CTT/300/02/06/TECH

23 May 23

### PERFORMANCE TRIAL OF HPAC NO. 3 - INS KESARI

Safety device checks. (d)

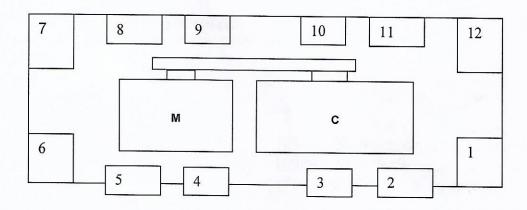
- Observation. Following observed during trial: -
  - (a) Instrumentations cable not secured.
  - (b) Auto cut-in and cut-out not operating as per design.

Ser	Description	Unit	Design Value	HPAC No.3	
(i)	1st stage Pressure relief valve	Bar	06		
(ii)	2 <sup>nd</sup> stage Pressure relief valve	Bar	33	33	
(iii)	3 <sup>rd</sup> stage Pressure relief valve	Bar	33	33	
(iv)	Auto cut off	Bar	30	23	
(v)	Auto cut in	Bar	25	20	
(vi)	Manual drain	Sat/Unsat		Sat	
(vii)	Auto drain	Sat	'Unsat	Sat

- 6. Recommendations. Following is recommended: -
  - (a) Liquidation of defects/ observations mentioned at Para 5 ibid.
  - (b) Extension of running hours may be accorded for normal exploitation of HPAC No 3 post liquidation of above observations by SS.
